Wisconsin Department of Transportation

Proposal #03: 1100-20-77

**IH 41 Zoo Freeway
Silver Spring Dr to Good Hope Rd
IH 41
Milwaukee County**

This is Addendum No. 01, which provides for the following:

Addendum No. 01
ID 1100-21-70
Revised Sheet 38
June 26, 2025

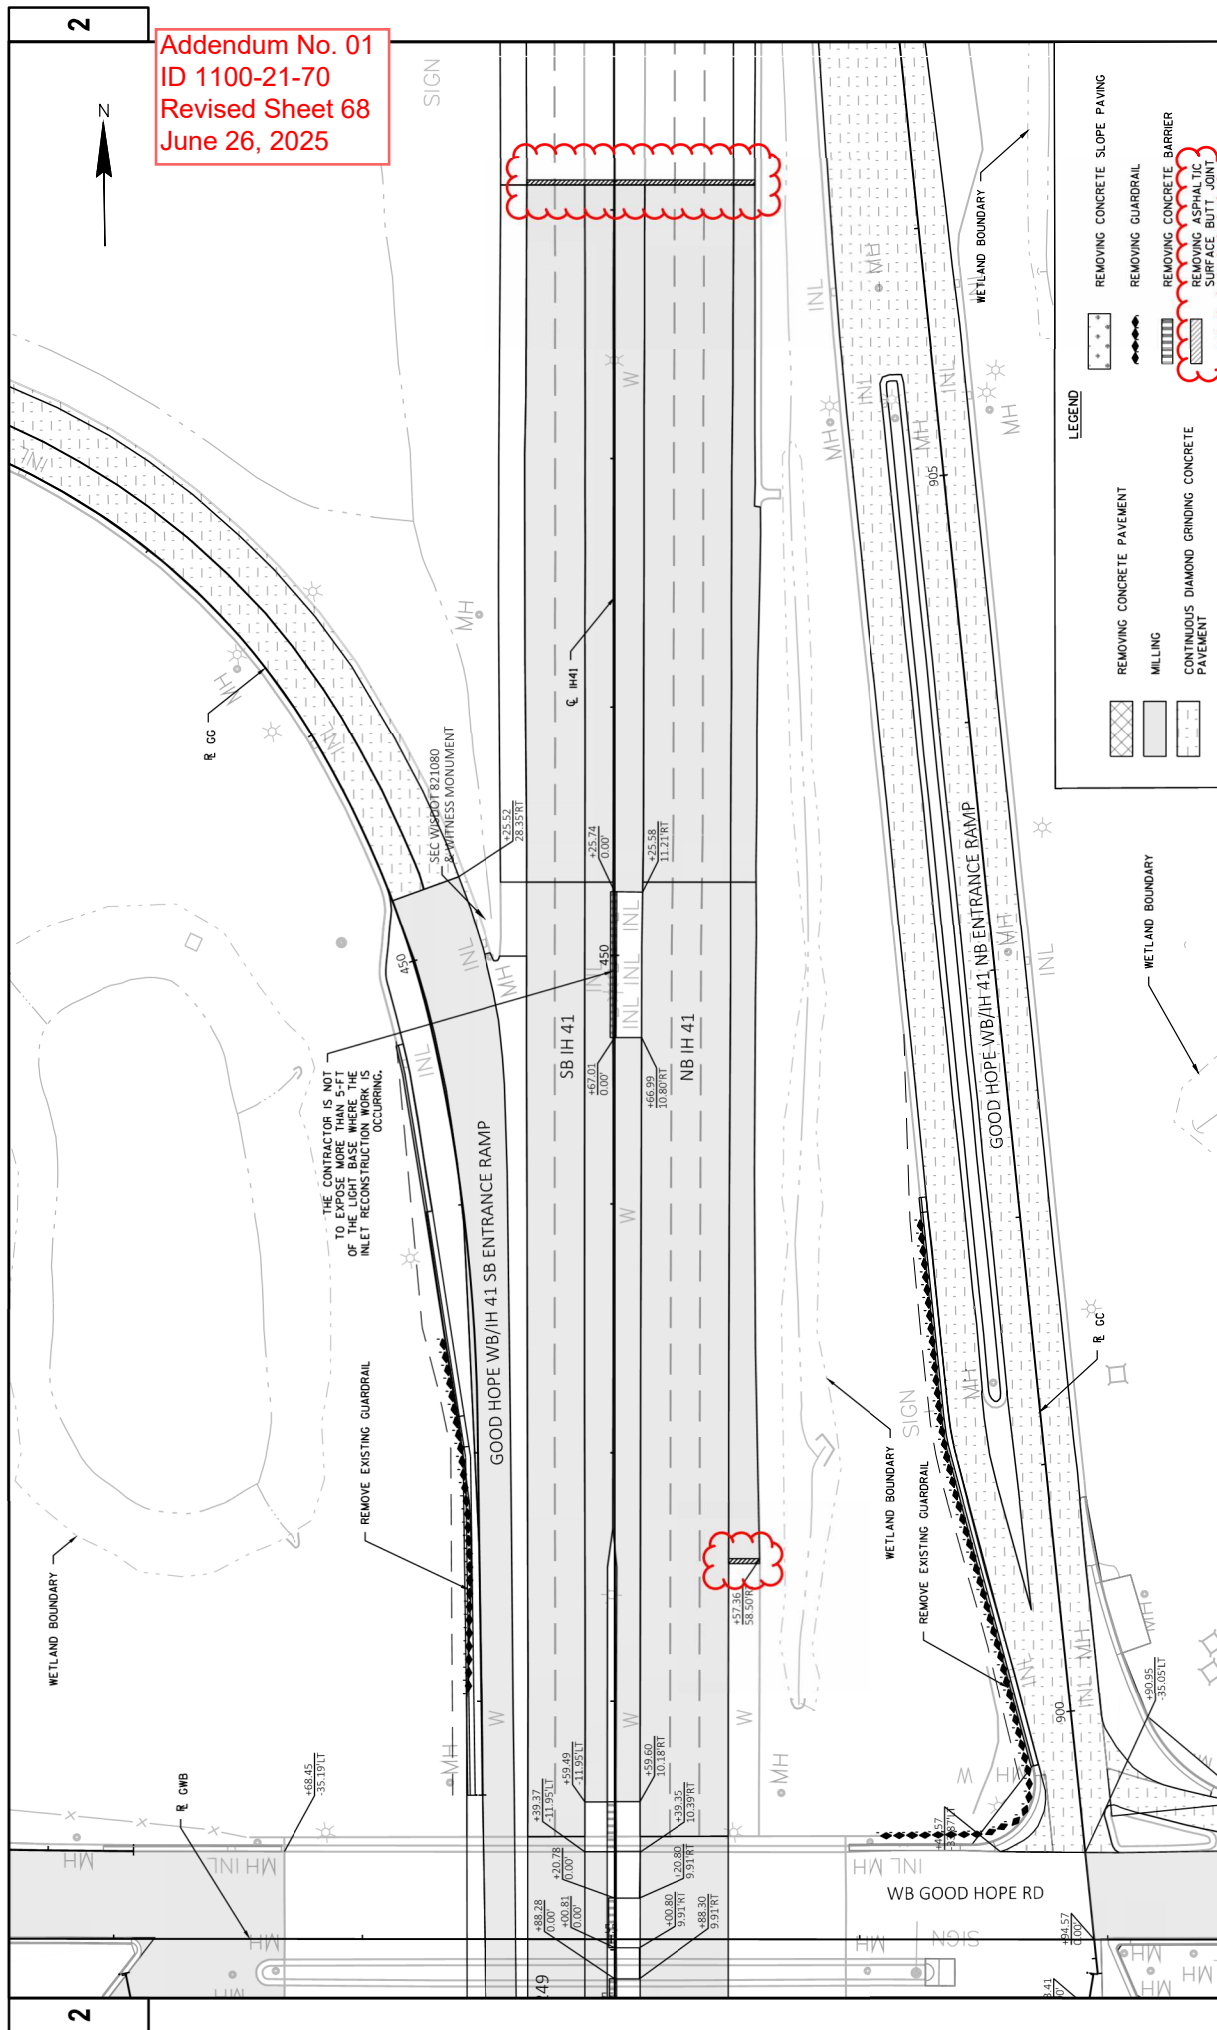
Revised Plan Sheets – 1100-21-70	
Plan Sheet	Plan Sheet Title (brief description of changes to sheet)
38	Added construction detail for removing asphaltic surface butt joint
68	Identified location of removing asphaltic surface butt joint
71	Identified location of removing asphaltic surface butt joint
72	Identified location of removing asphaltic surface butt joint
446	Added column for removing asphaltic surface butt joint bid item

SHEET 17A

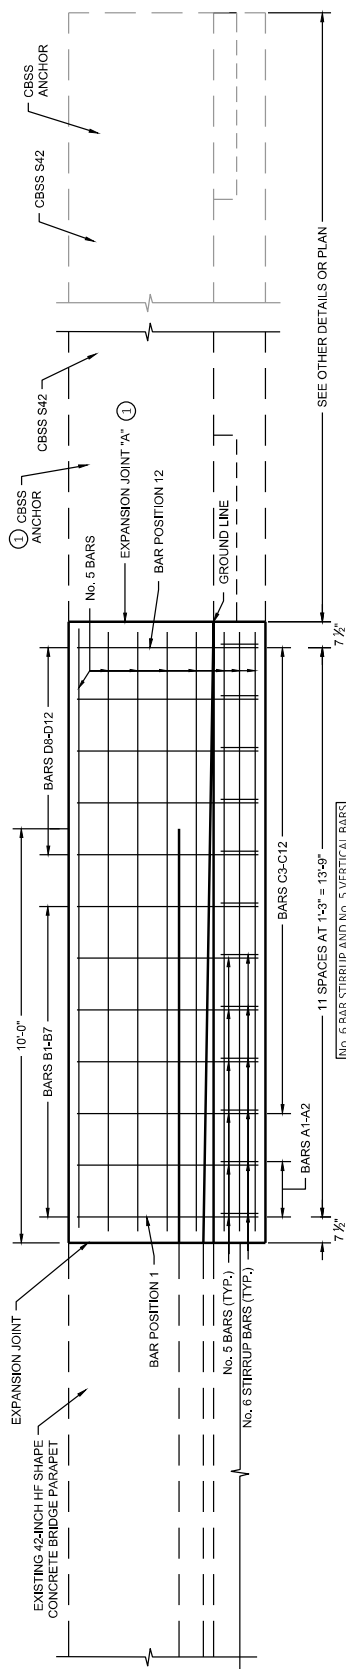
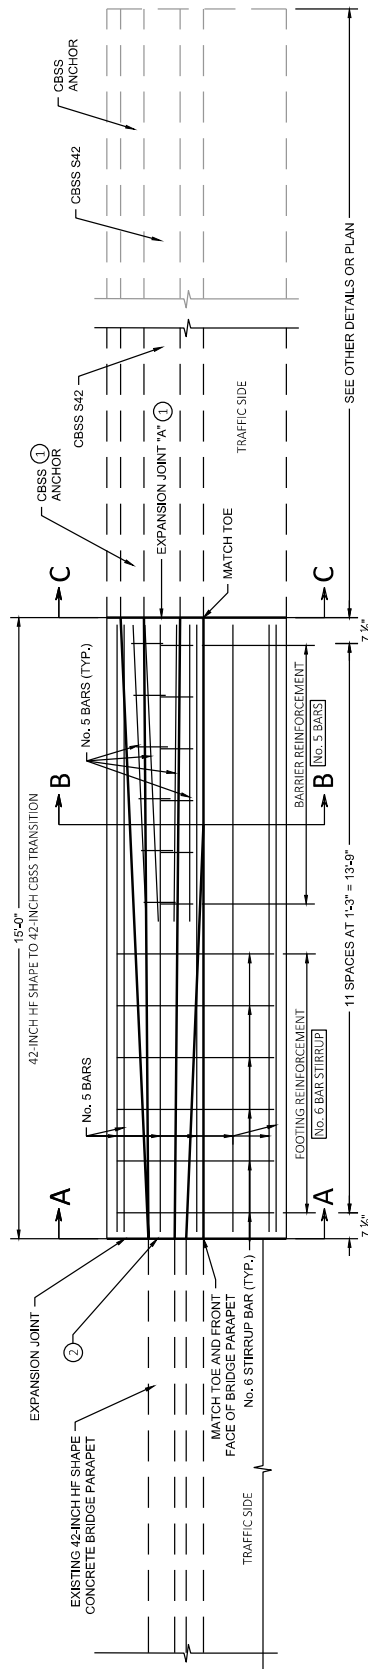
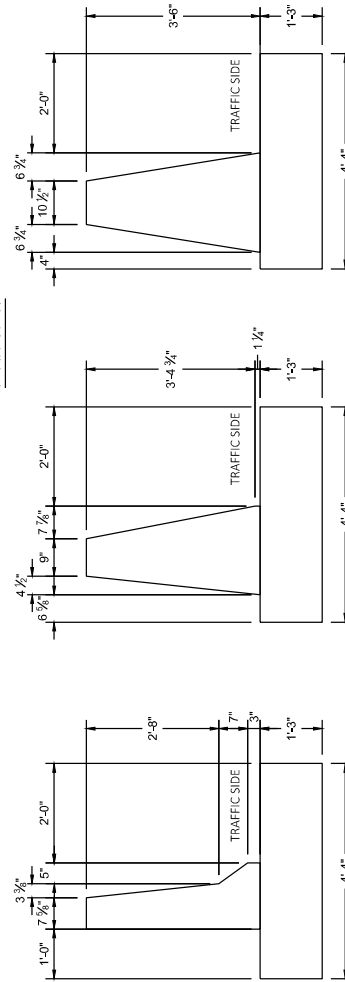
Added Plan Sheets – 1100-21-71	
Plan Sheet	Plan Sheet Title (brief description of why sheet was added)
17A	Added construction details
17B	Added construction details
17C	Added construction details
17D	Added construction details
17E	Added construction details
